Technical Note

Subject: Dinting Vale - Air Quality Assessment Technical Note

Table 1-1: HPBC response

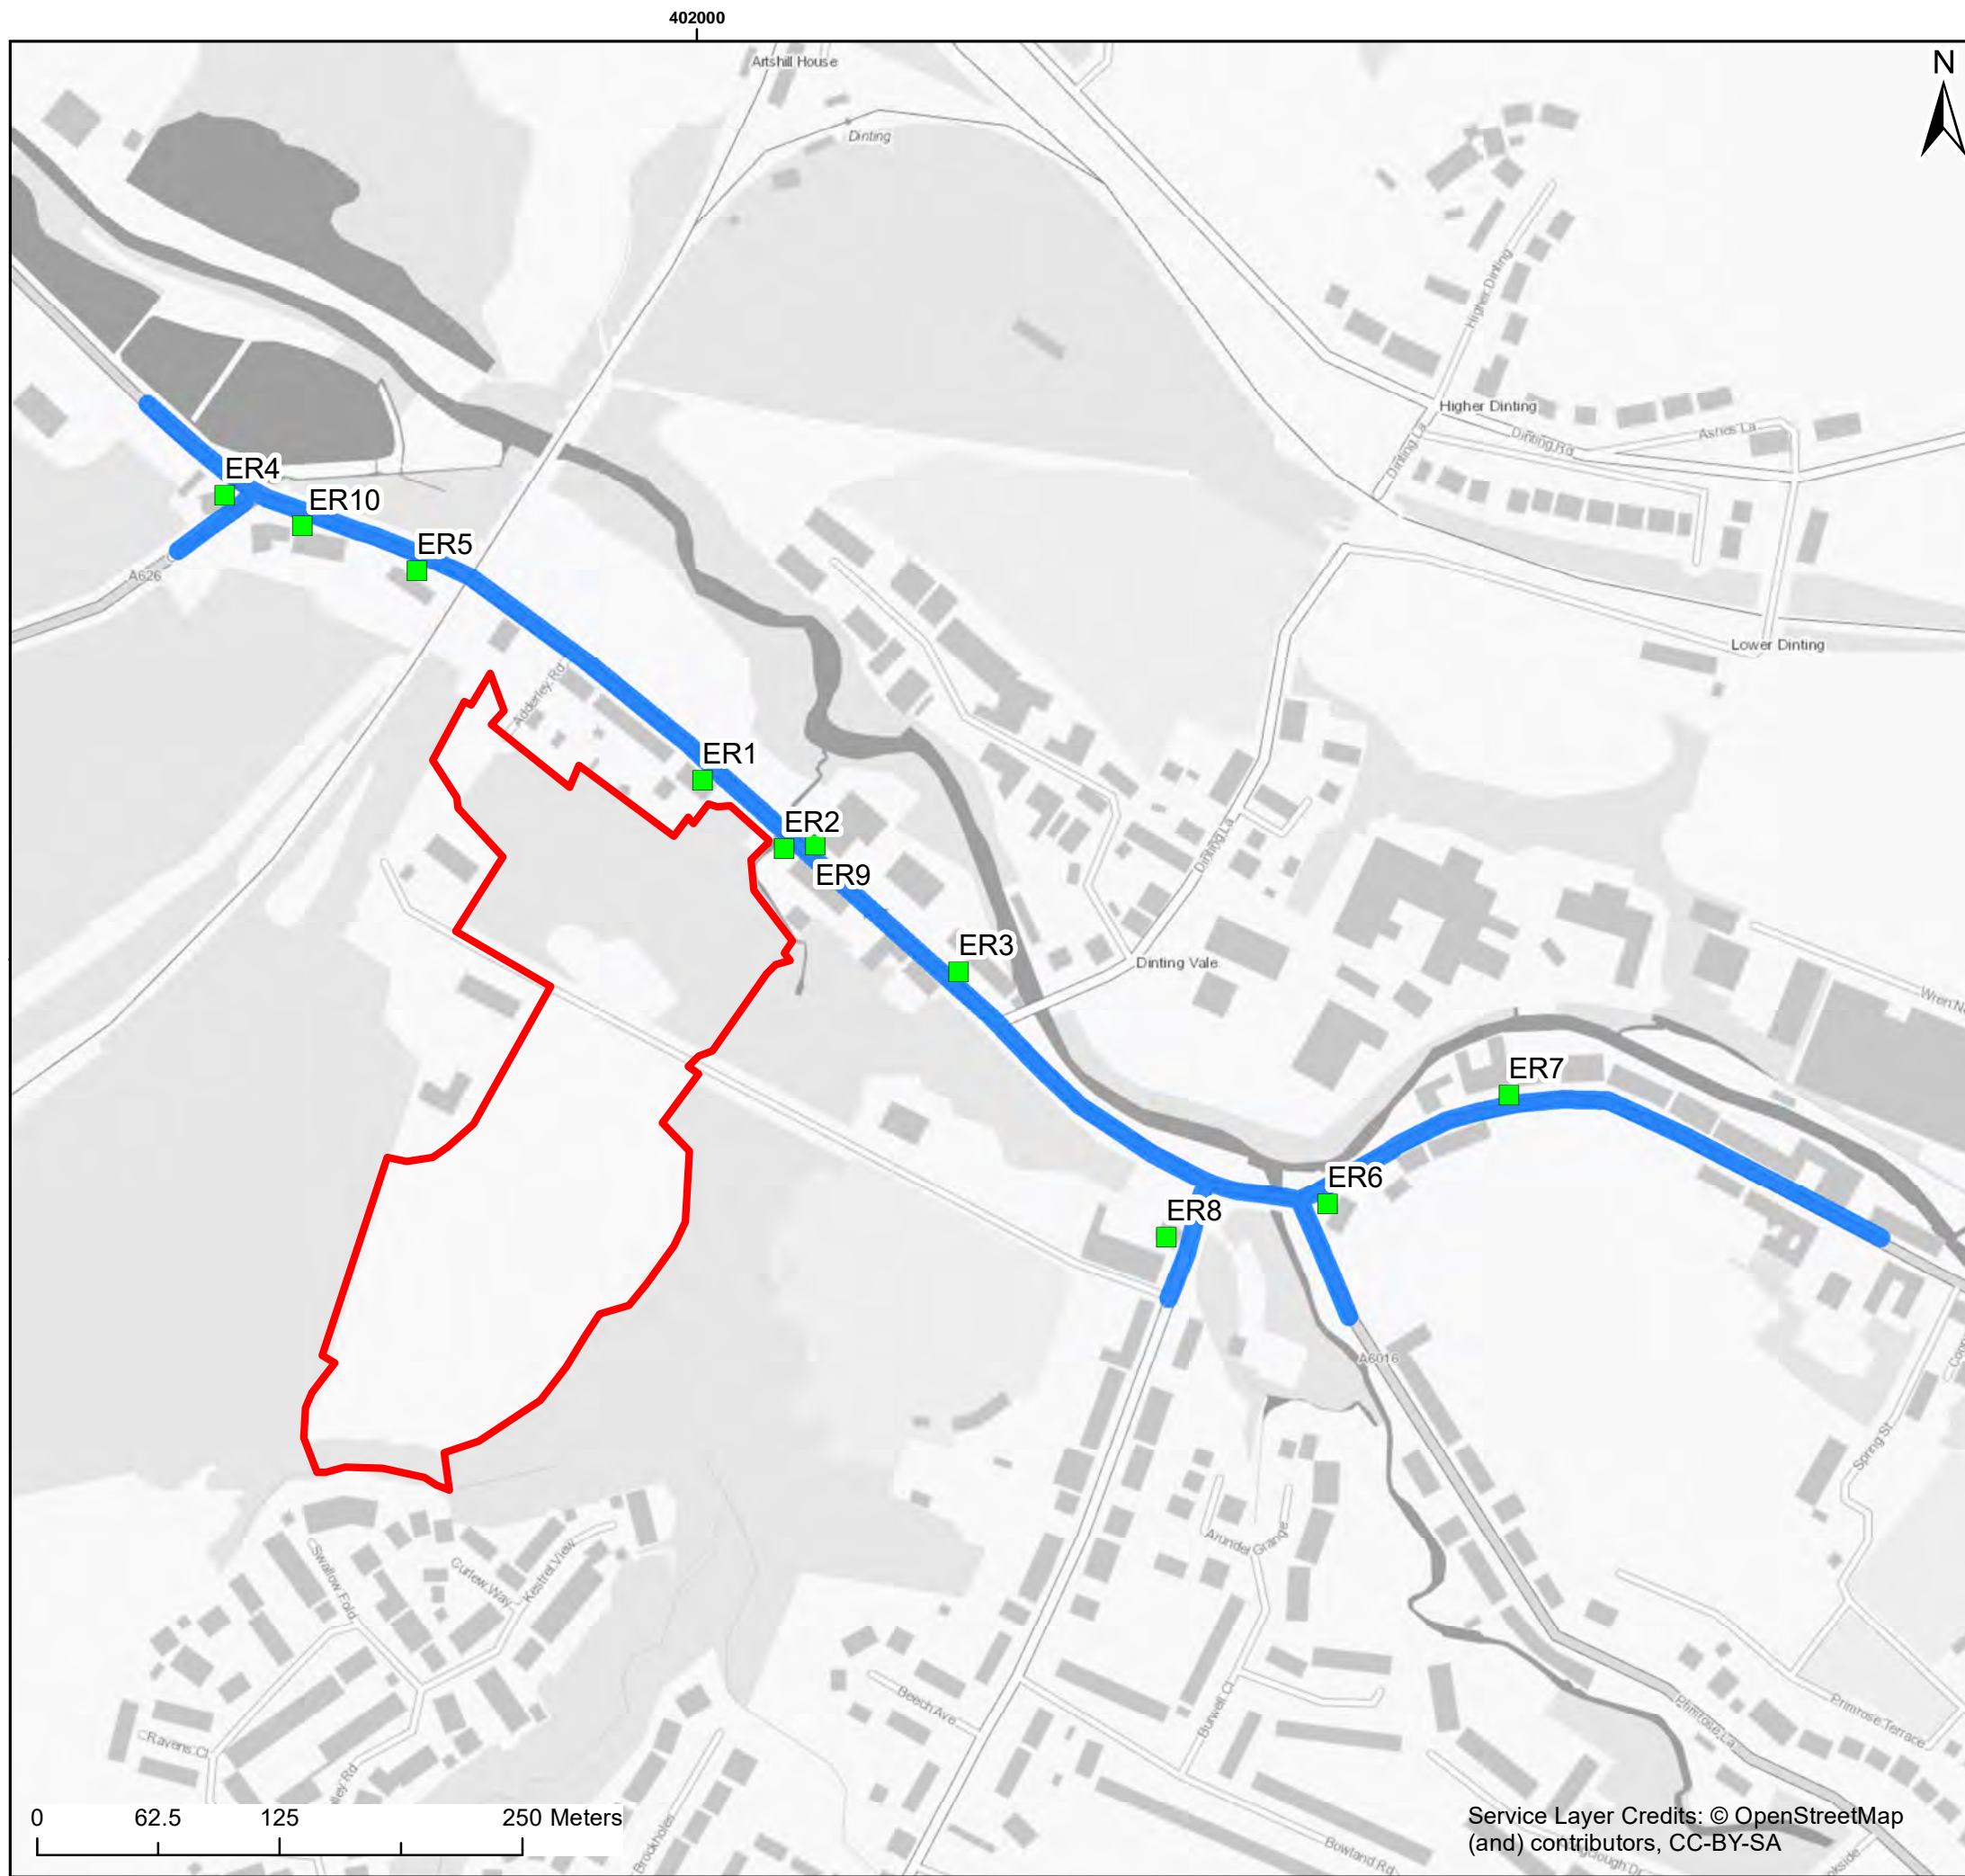
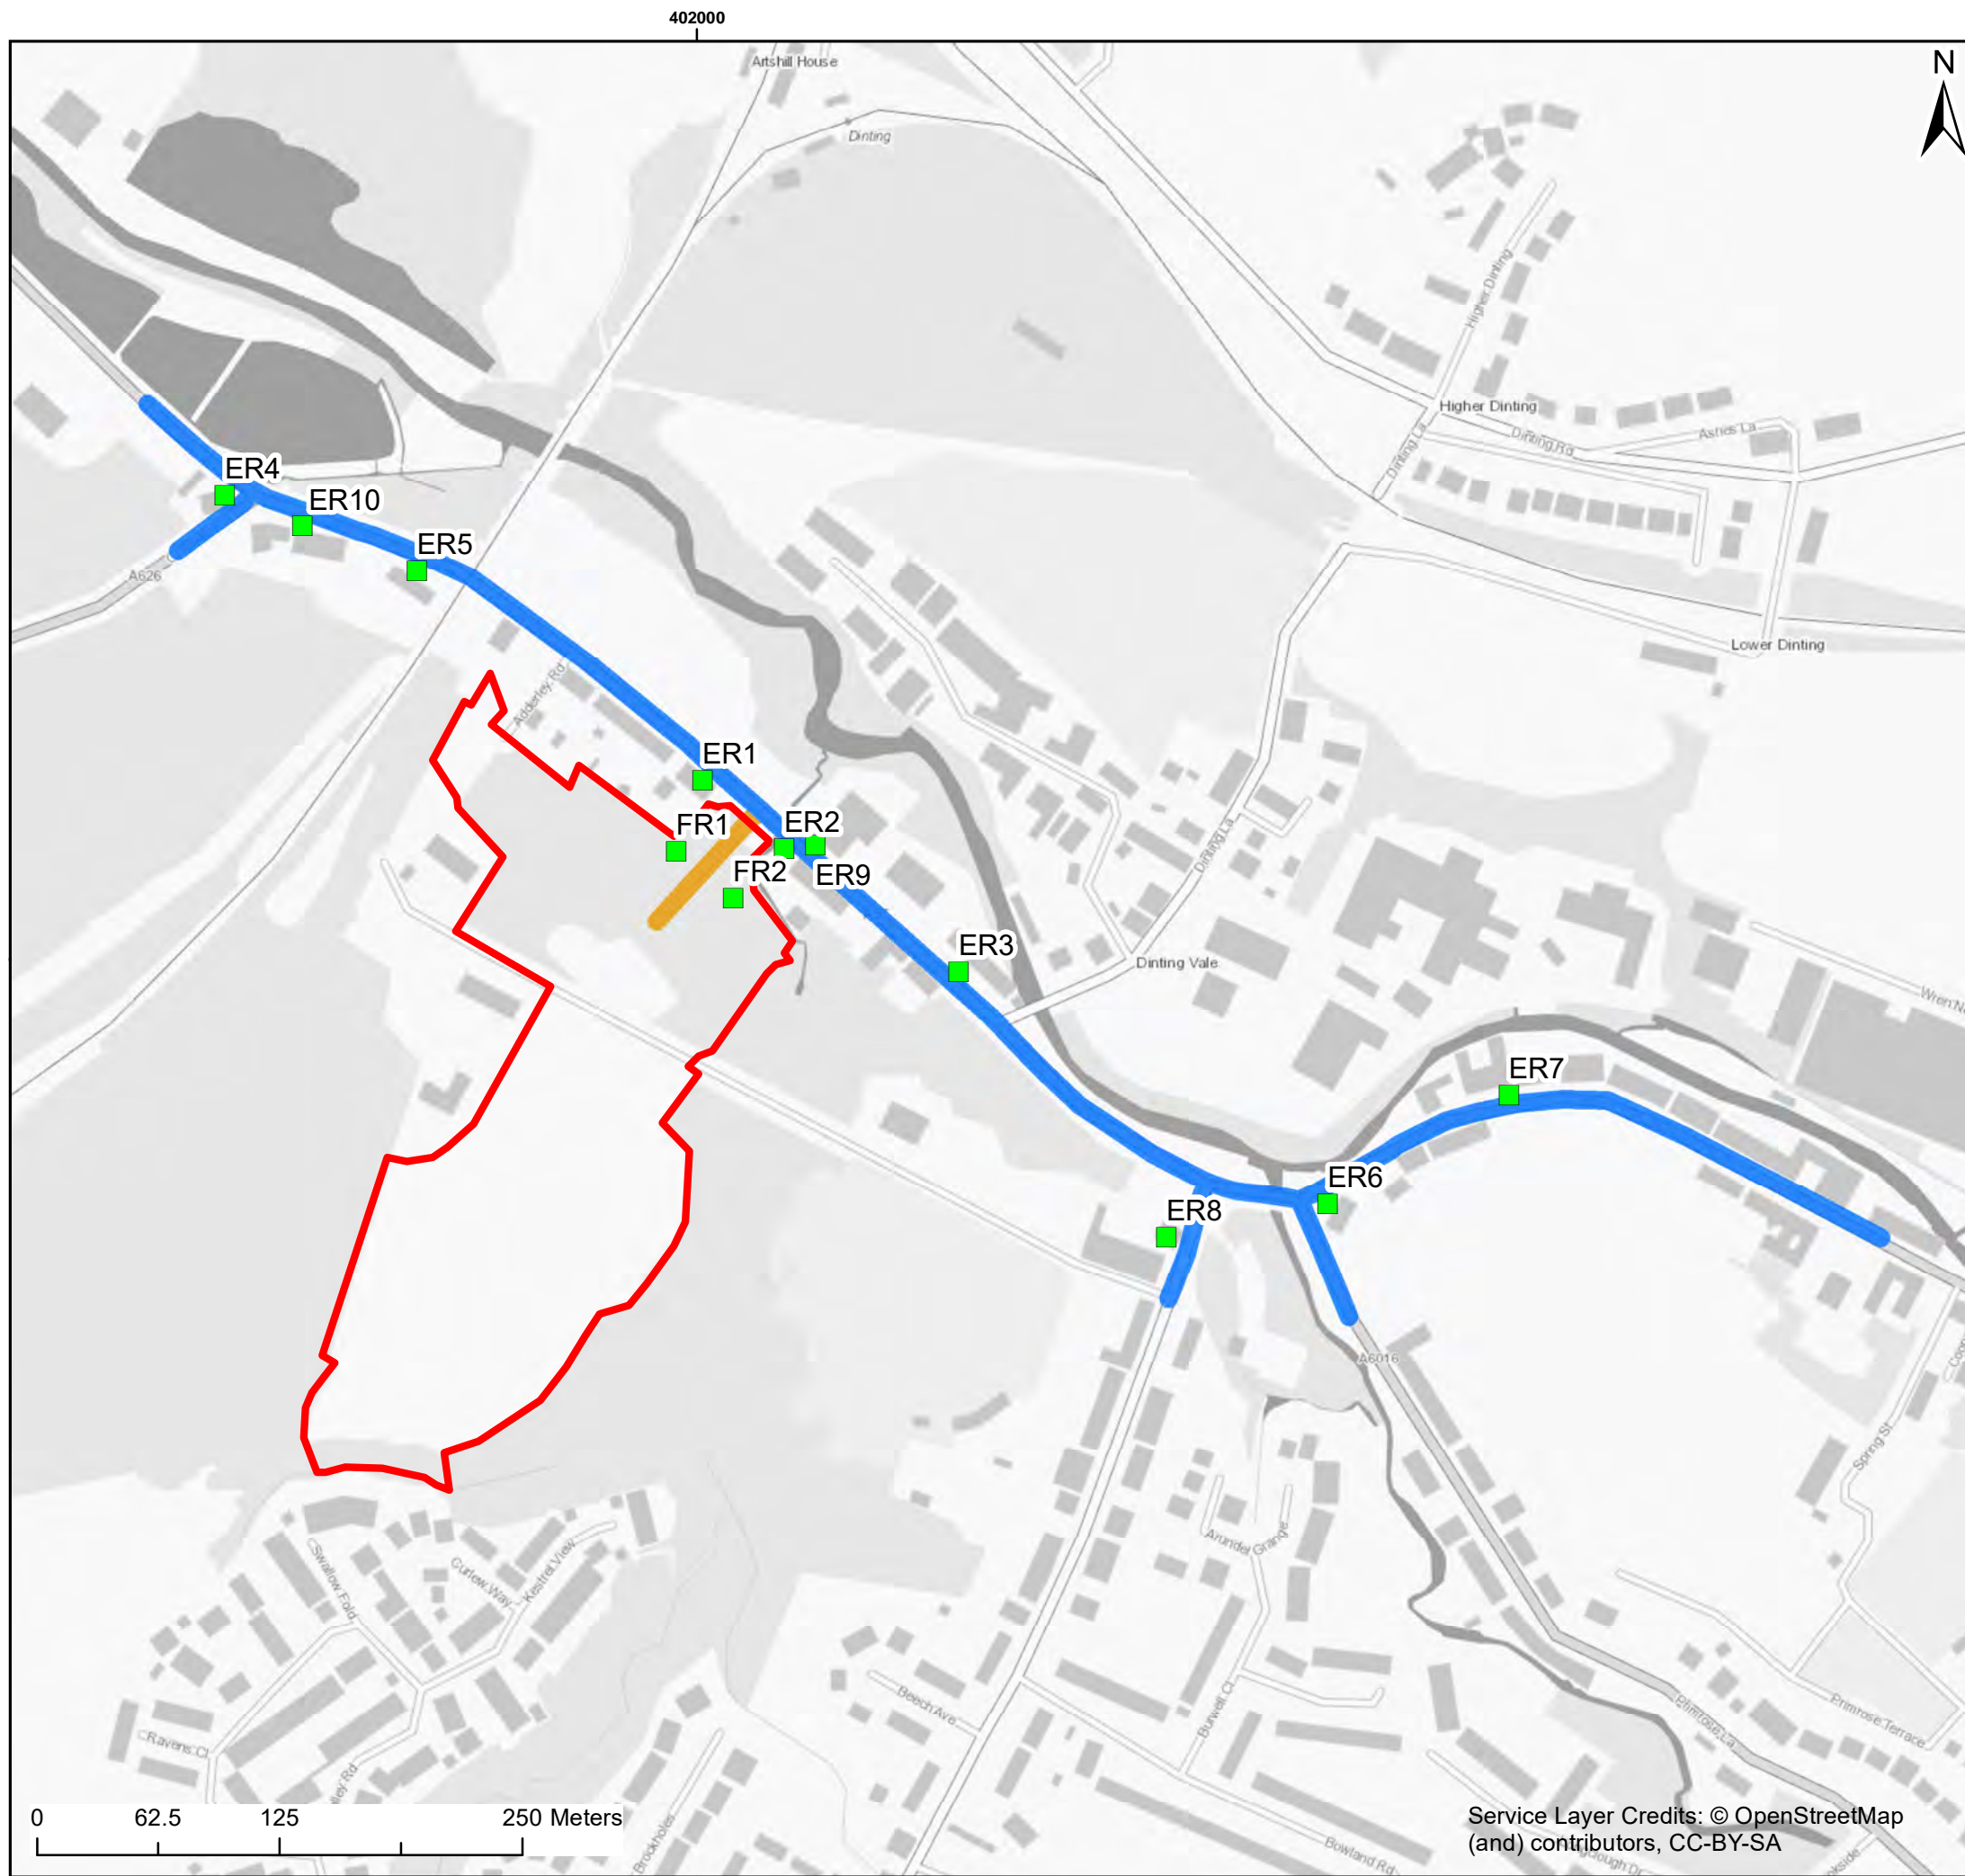
- *Request:* Consideration of the impact of the gradient of the access road.
Response: Included in the 'with development' scenarios, as detailed in Section 3.4.1.4.

Again it would be better if this was represented graphically detailing exactly the areas where either the gradient was applied (and what gradient was chosen – as agreed by the HA)

<p>HPBC Request December 2022: Consideration of the impact of the gradient of the access road.</p>	<p>Figures 3.0 and 4.0 in Appendix B show the gradients of the roads modelled in the with and without development scenarios. As shown in Figure 4.0, a road gradient of 10% was included in</p>

Date / Document	Request*	Response
	<p>RHDHV Response March 2023: Included in the ‘with development’ scenarios, as detailed in Section 3.4.1.4.</p> <p>“The main access road into the Proposed Development includes a single length of road at a gradient of 1:10. This was incorporated into the ‘with development’ scenarios to identify the impact on the adjoining residential properties (modelled existing receptors ER1 and ER2), as requested by the Pollution Specialist Officer. The impact of the gradient on road traffic emissions was calculated using the latest version of the Emission Factor Toolkit (EFT), in accordance with Defra guidance in LAQM.TG (Defra, 2022).</p> <p>HPBC Request July 2023: Again it would be better if this was represented graphically detailing exactly the areas where either the gradient was applied (and what gradient was chosen – as agreed by the HA)</p>	<p>the with development scenario. As detailed in the revised air quality assessment, there is only a single length of road with a gradient of 1:10. The access road has an initial gradient of 1:30 for 10m from the junction with Dinting Vale, and all other gradients are a max. gradient of 1:20. Therefore, the assessment is considered robust.</p>
